Comments of Growth Energy on the Air Resources Board Staff Presentations at a Public Consultation Meeting on Regulations for Commercialization of Alternative Diesel Fuels

These comments respond to the CARB staff's request for comments on the staff's presentations at the November 21, 2014 public consultation meeting on the proposed adoption of regulations to govern commercialization of alternative diesel fuels, including as part of compliance strategies for the California Low Carbon Fuel Standard ("LCFS") regulation.

Figure 1-1
Linear and Staff Threshold Models for Biodiesel NOx Impacts

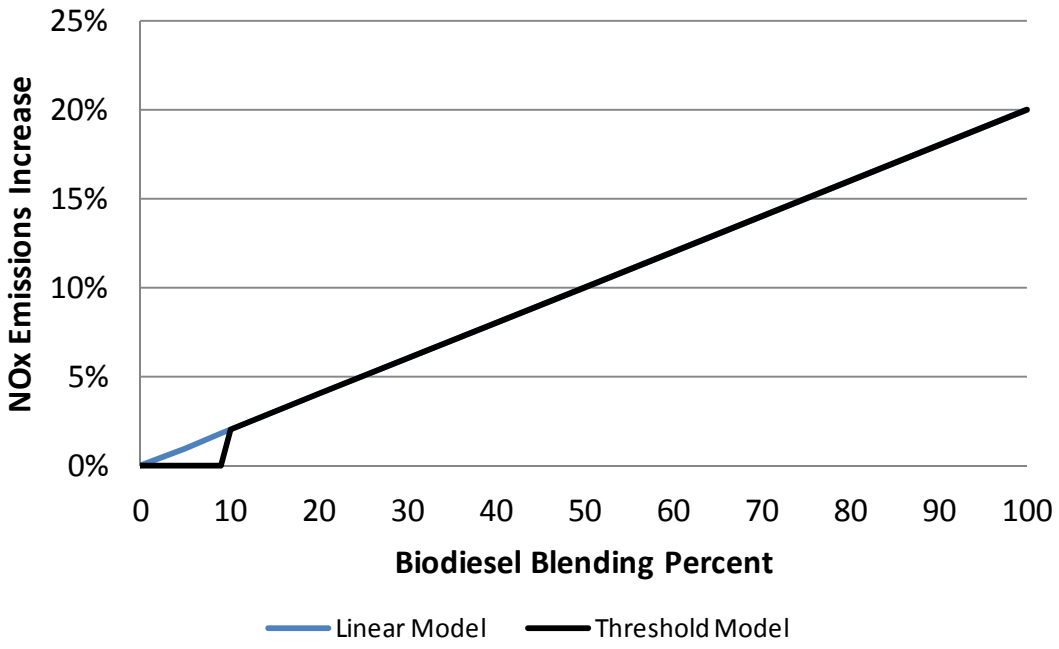
Existing research on the NOx emission effects of biodiesel has consistently been conducted under the hypothesis that the emission effect will be linearly proportional to the blending percent of neat biodiesel (B100) with the base diesel fuel. The Linear Model that has been accepted by researchers is shown as the blue line in Figure 1-1. The Staff position cited above is that biodiesel fuels do not increase NOx emissions until the fuel blend reaches 10% biodiesel. This so-called Staff Threshold Model departs from the Linear Model that underlies past and current biodiesel research by claiming that NOx emissions do not increase until the biodiesel content reaches 10 percent.

The Staff Threshold model is justified by the statement: "Based on our analysis to date, we have found that diesel blends with less than 10 percent biodiesel by volume (<B10) have no significant increase in any of the pollutants of concern." Other portions of the ISOR state that Staff will track "… the effective blend level on an annual statewide average basis until the effective blend level reaches 9.5 percent. At that point, the biodiesel producers, importers, blenders, and other suppliers are put on notice that the effective blend-level trigger of 9.5 percent is approaching and mitigation measures will be required once the trigger is reached."[5] Until such time, NOx emission increases from biodiesel blends below B10 will not require mitigation.

Figure 2-1
NOx Emission Increases Observed in Biodiesel Research Cited in Staff ISOR

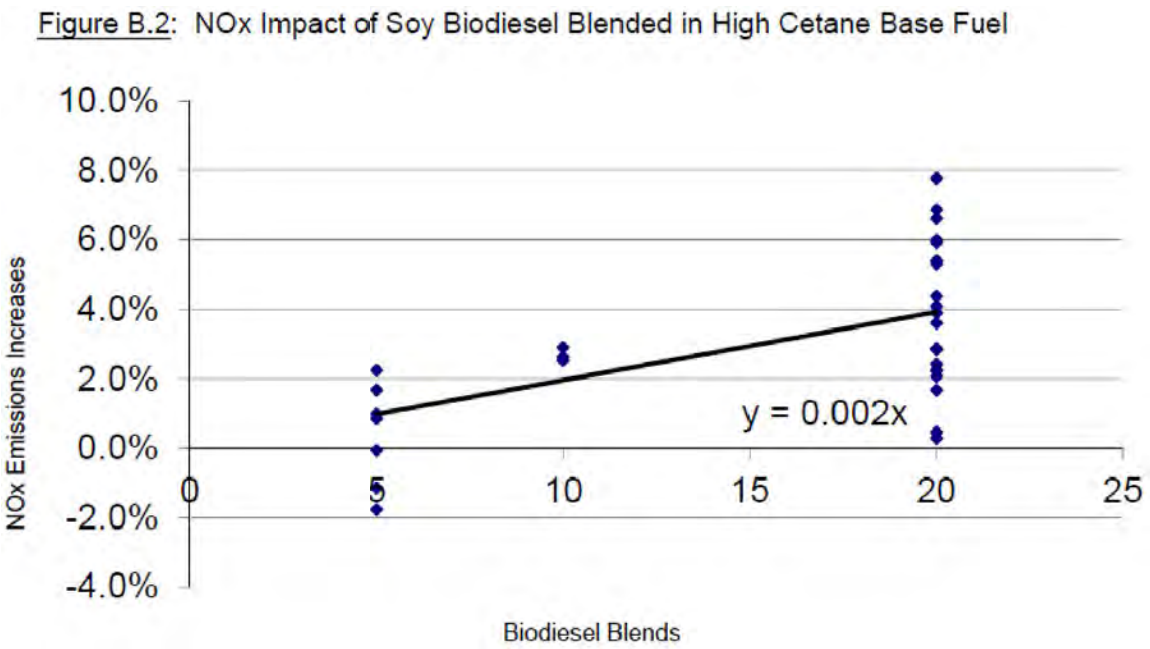
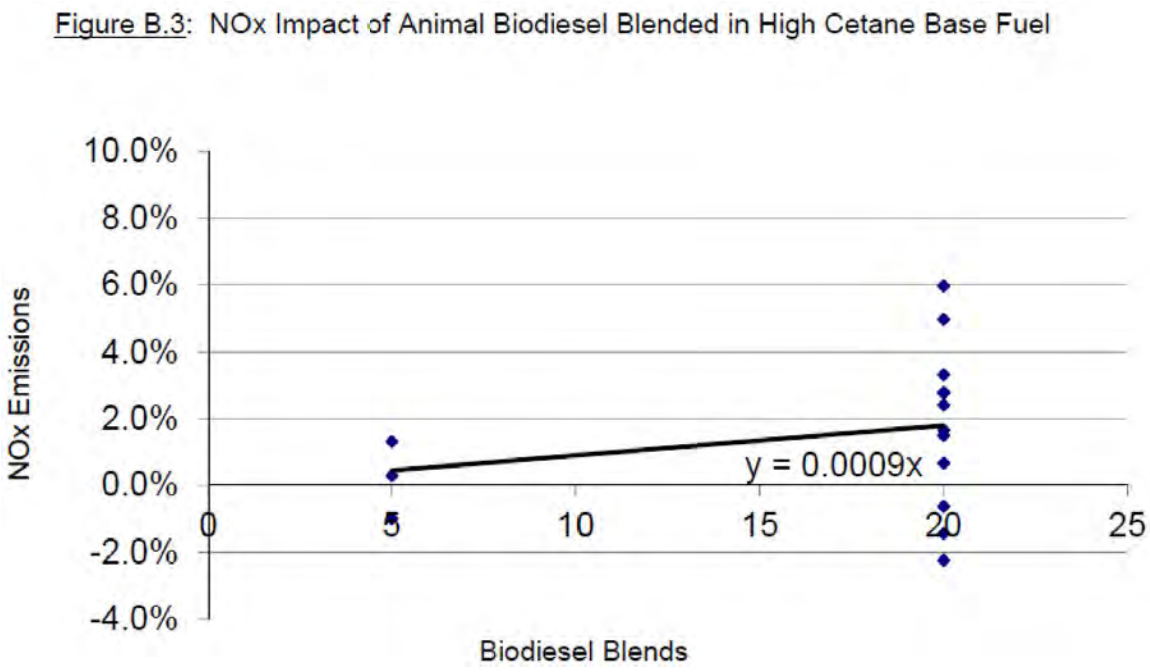
Figure 2-1 reproduces two exhibits from Appendix B that show increasing trends for NOx emissions with the biodiesel blending level. Based on the slopes of the trend lines,

soy-based biodiesels are shown to increase NOx emissions by approximately 1% at B5, 2% at B10, and 4% at B20. Animal-based biodiesels are shown to increase NOx emissions by about one-half as much: 0.45% at B5, 0.9% at B10, and 1.8% at B20. Although there is substantial scatter in the results, these data do not appear to support the Staff Threshold Model that biodiesel does not increase NOx emissions at B5 but does so at B10.

Figure 3-1a
Durbin 2011 Assessment: 40 mph Cruise Cycle NOx Emissions Increases for Soy-Biodiesel Blends (2006 Cummins Engine)

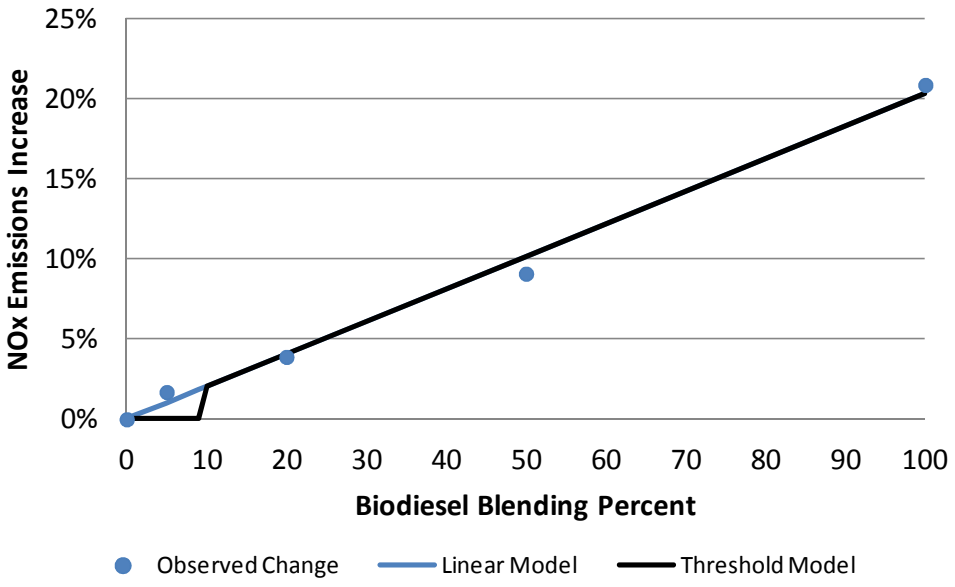
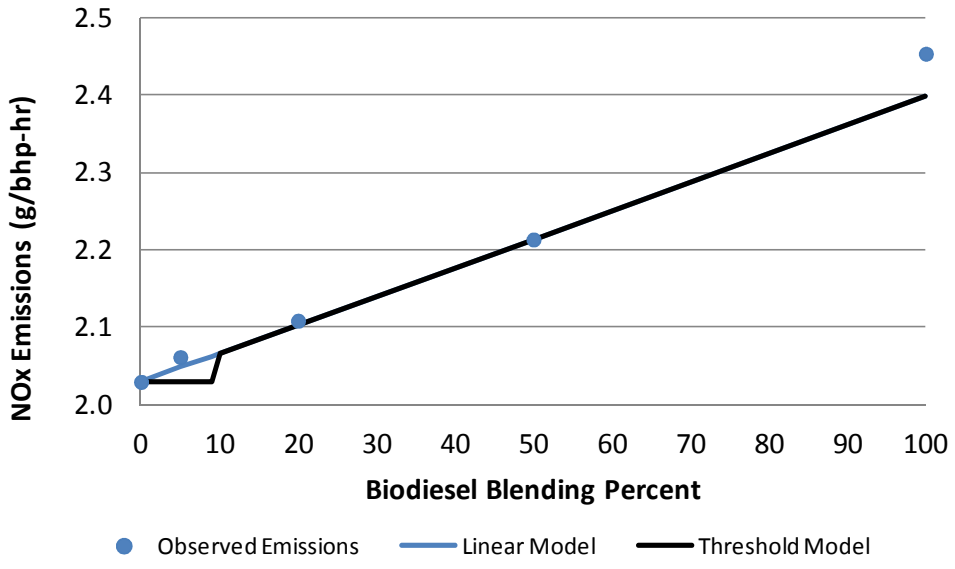
Figures 3-1a and 3-1b display the trend of NOx emissions with blending percent for the soy-based biodiesel on the 40 mph cruise cycle. Figure 3-1a plots the percentage increases as reported by Durbin 2011 in contrast to two different analytical models for the relationship:

In Figure 3-1a, the linear model is an Excel trendline for the computed percent changes. While the data violate a key assumption for the proper use of regression analysis, this approach is the only way to establish a trendline given the form in which Durbin 2011 tabulates the data and presents the results of its testing.

Figure 3-1b plots the actual measured emission values in g/bhp-hr terms in contrast to the same two analytical models. Here, the linear model line is determined through a proper use of regression analysis, in which each emission average in g/bhp-hr terms is weighted inversely by the square of its standard error, using the data for ULSD, B20, B50 and B100 (i.e., excluding the B5 data point). In the case of this engine and biodiesel fuel, both forms of assessment show generally the same trend for NOx emissions as a function of blending percent. Although the NOx emission increases for B5 may fail the t-test for significance, emissions are increased at B5 and the B5 data point is fully consistent with the Linear Model. The Threshold model is clearly a less-satisfactory representation of the test data.

Note that the slope of the trendline (Figure 3-1a) is greater than the slope of the regression line (Figure 3-1b). In the latter figure, the B100 data point stands above the regression line, which passes below it. The regression line (but not the trendline) is fit in

Figure 3-2a
Durbin 2011 Assessment: FTP NOx Emissions Increases for Animal-based Biodiesel Blends (2006 Cummins Engine)

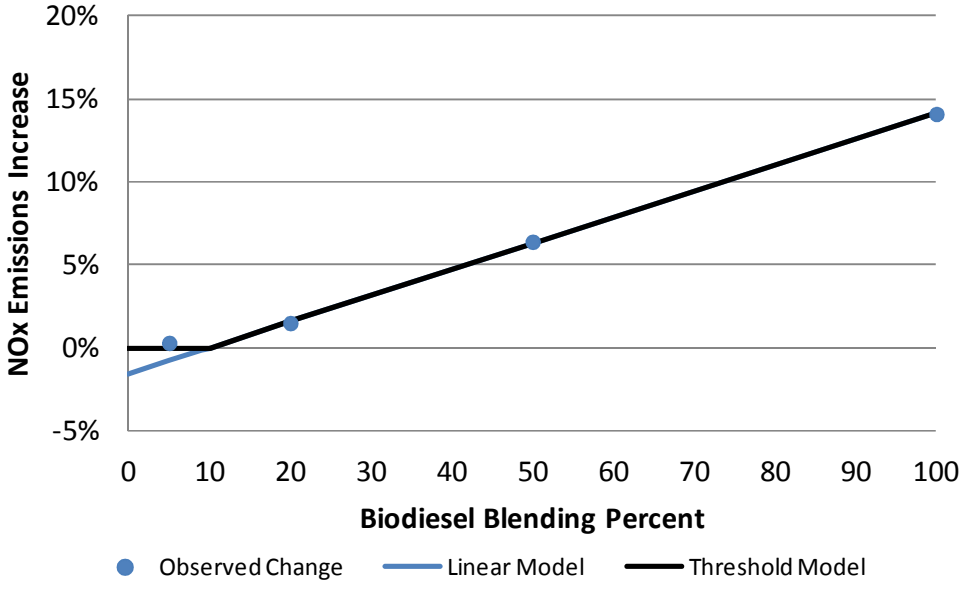
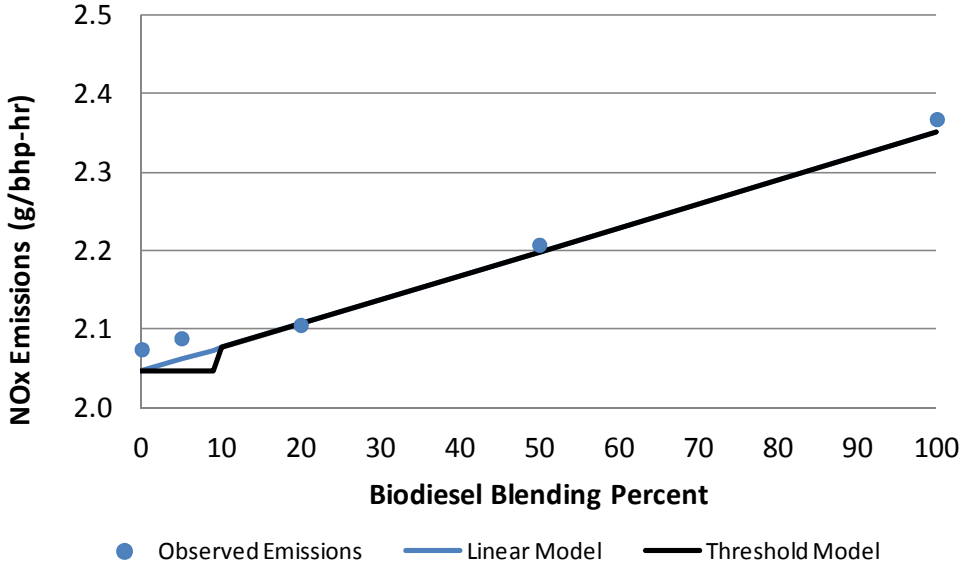
Figures 3-2a and 3-2b display the trend of NOx emissions with blending percent for the animal-based biodiesel on the FTP test cycle as reported by Durbin 2011 and as re-assessed in this report using regression analysis, respectively. As Figure 3-2a shows, the NOx percent change values reported by Durbin 2011 appear to follow the Staff Threshold model in that NOx emissions are not materially increased at B5, but are increased significantly at B20 and above. As a result, the blue trendline in the figure (fit from the B20, B50 and B100 data points) has a negative intercept.

Figure 3-2b paints a very different picture from the data. Here, the ULSD and B5 data points stand above the weighted regression line (blue) developed from the data for ULSD, B20, B50 and B100. In the data used to fit the regression line, the ULSD data point has the largest uncertainty (±0.013 g/bhp-hr) while the other three data points (B20, B50, and B100) have uncertainties of ±0.002 g/bhp-hr (one case) and ±0.001 g/bhp-hr (two cases). Considering all of the data, the B5 data point has the second highest uncertainty (±0.007 g/bhp-hr). The regression line closely follows a linear model with a high R^2 (0.981) considering the weighted errors, while the ULSD and B5 points lie above it.

Because the ULSD data point is subject to more uncertainty and appears to be biased high compared to the regression line, the NOx percent changes computed by Durbin 2011 are themselves biased. The trendline result in Figure 3-2a that appeared to be supportive of the Staff Threshold model now appears to be the result of biases in the ULSD and B5 emission averages.

Figure 3-4
Durbin 2011 Assessment: ISO 8178 Cycle NOx Emissions Increases for Soy-based Biodiesel Blends (1998 Kubota Engine, Test Series 1 and 2 Combined)

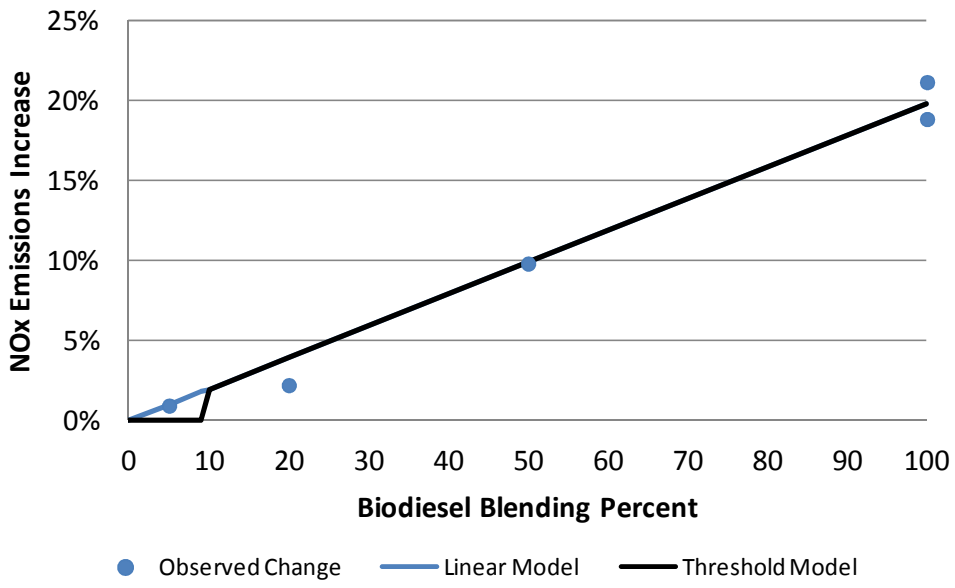
Figure 3-4 displays the trend of NOx emissions with blending percent for the first and second test series combined. As the figure shows, the available data points scatter around the trendline determined from the emission change percentages (not from regression analysis). The B20 data point falls below the trend line while the two B100 data points bracket the trend line. It is not possible to explain the divergence of the B20 data point

because the emissions data for the second test series are not published in Durbin 2011. The B5 data point clearly supports the Linear Model and is inconsistent with the Staff Threshold Model.

Figure 1. CARB Biodiesel Forecasts

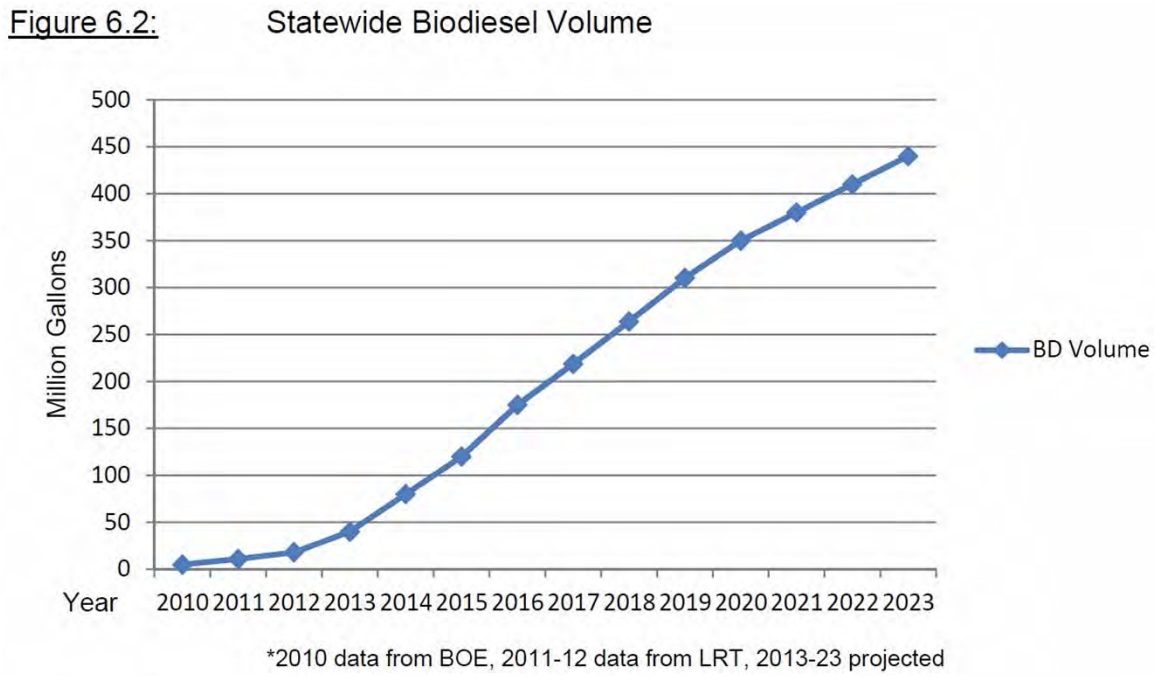
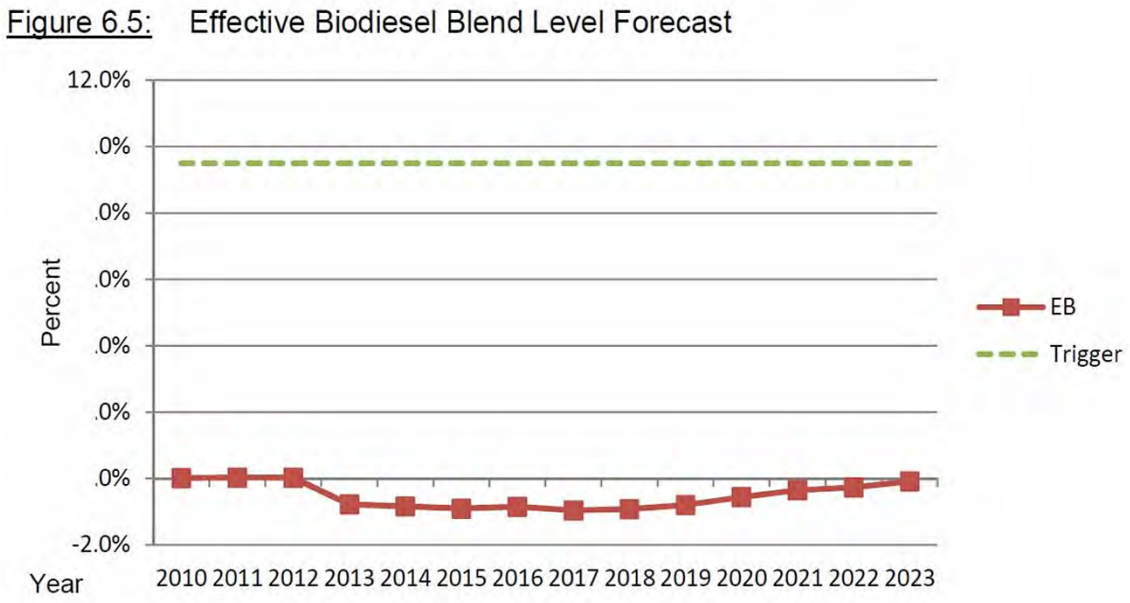
Source: CARB Initial Statement of Reasons. Note that Figure 6.5 is reproduced directly from the ISOR, which is missing some increments on the y-axis.
